भारतीय प्रतिस्पर्धा आयोग  
Competition Commission of India

Tender No.: RFP/CCI-ITD/2014/01

**CORRIGENDUM**

The Bid Evaluation Committee (BEC) held a pre-bid Conference with the prospective bidders on 25<sup>th</sup> February 2014 in the Office of CCI. After having considered all the suggestions/views received from the bidders, the following amendments in RFP have been approved by the competent authority.

### 2.3.2 CCI Office

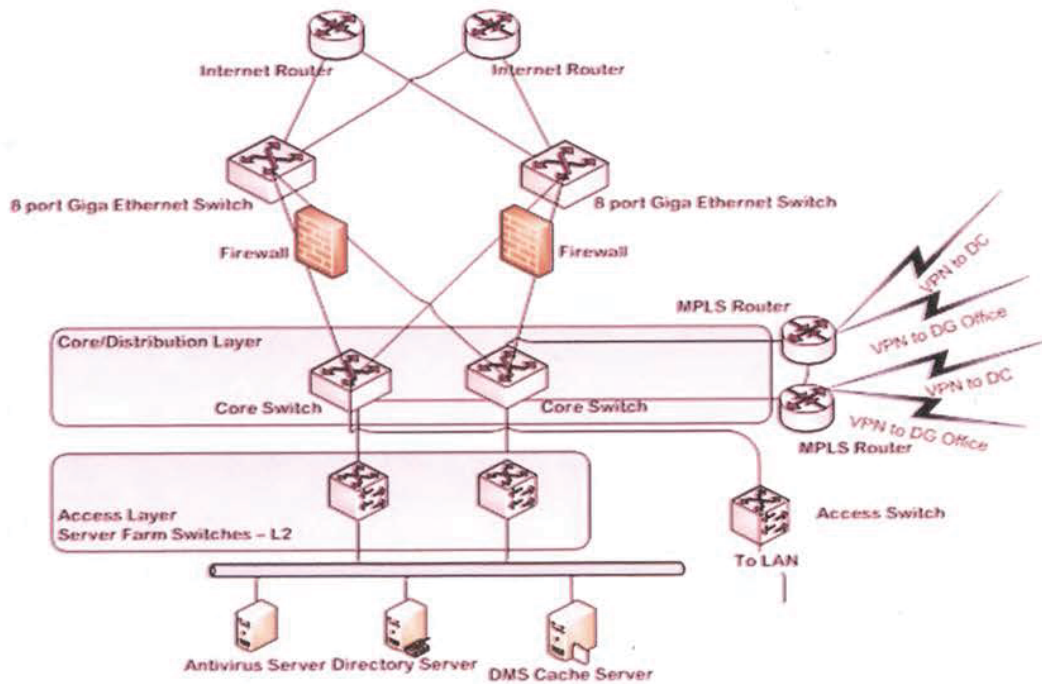
11	Volume- 2, Page No. 9-10, 2.3 Deployment Architecture	2.3.1 Data centre, 2.3.2 CCI Office, 2.3.3 DG Office	Modified diagram - refer Annexure -1
12	Volume- 2, Page No. 11, 3 General Specification	3. General Specification	New Specifications added - refer Annexure - 2
13	Volume- 2, Page No. 49, 4.6.4 Technical Specifications	System Management: The solution should integrate with the existing LDAP infrastructure for Authentication and provide Administrative roles based on Directory groups. Should have out-of- the-box integration with Cisco Iron Port, Microsoft AD-RMS, and the proposed solution.	System Management: 2. The solution should integrate with the existing LDAP infrastructure for Authentication and provide Administrative roles based on Directory groups.
14	Volume- 2, Page No. 52, 4.6.4 Technical Specifications	Automated Remediation /Data Protection : Automatically copy, move, encrypt, and quarantine files which violate policy. Automatically Notify the file owner and automatic remediation by applying Microsoft RMS templates	Automated Remediation /Data Protection : Automatically copy, move, encrypt, and quarantine files which violate policy. Automatically Notify the file owner and automatic remediation.
